You have a unit that is affected by this recall. Vehicle in Question : VIN # 1FDXE4 [REDACTED], SVO 1736

# IMPORTANT SAFETY RECALL NOTICE

## MORryde U-Bolt Torque

EXHIBIT A

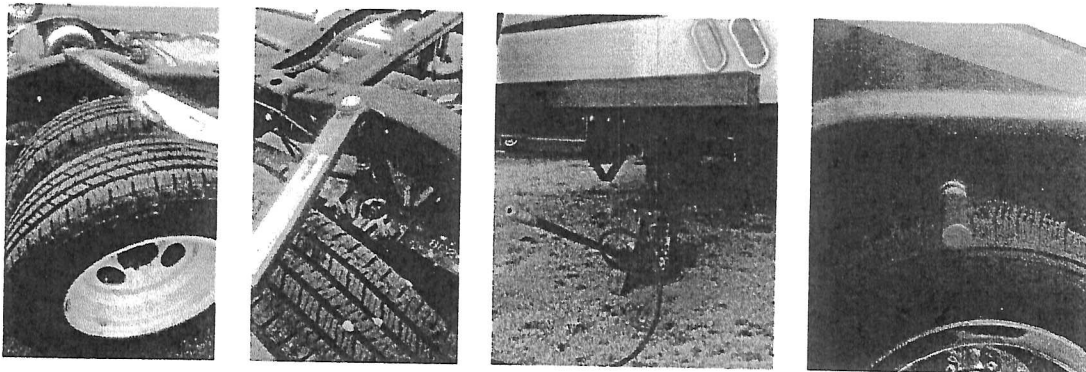
1. Set torque wrench to 170 ft-lb.
2. The best way to access the u-bolts is straight above the rear tires facing the sidewall of the unit. It may be necessary to use an air jack or floor jack under the rear hitch or frame extensions to provide access for the torque wrench and extension to fit under the sidewall. (Exhibit A)
